## Product Change Notice (PCN)

PCN Number: PCN-0451151R-01

Product(s) Affected: PJ-037BH

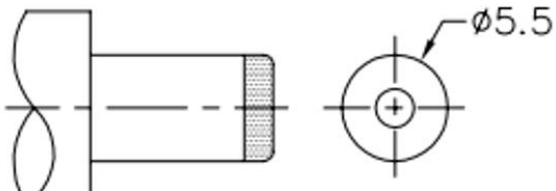
Description of Change: mechanical differences as shown below:

MATERIAL	PLATING
center pin	copper	nickel
terminal 1	brass	silver
terminal 2	copper alloy	silver
plastic	PBT

DESCRIPTION	MATERIAL	PLATING/COLOR
center pin	copper alloy	nickel
terminal 1	brass t=0.3 mm	nickel-silver
terminal 2	phosphor bronze t=0.3 mm	nickel-silver
housing	PBT (UL94V-0)	black
cover	PBT (UL94V-0)	black

**MATING PLUG**  
Jack Insertion Depth: **9.0 mm**

**MATING PLUG**  
Jack Insertion Depth: **9.8 mm**

Insertion/extraction force adjusted to 0.3 ~ 2.0 kg
